**Davis Joint Unified School District**

**ADDENDUM NO. 2**

Friday, October 16, 2020

Project: **Emerson Science Wing**  
2121 Calaveras Avenue  
Davis, California 95618

**GRADING PLAN**

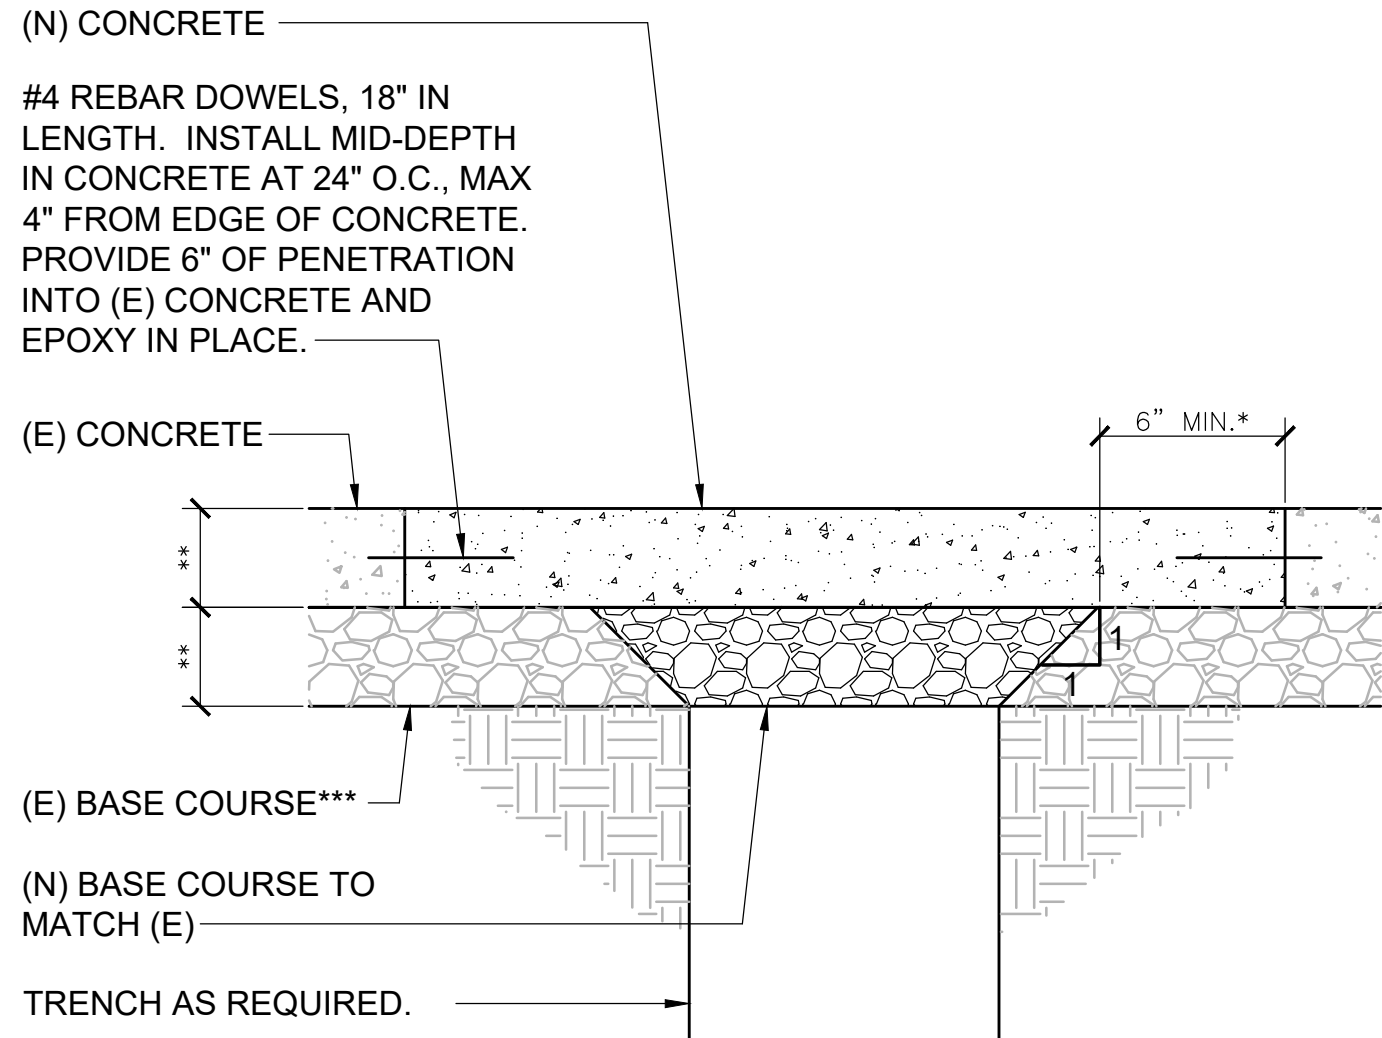
- A. NOTE:** Overlay of existing topography added to plan to further clarify extent of work. See attached sheet C6.01.
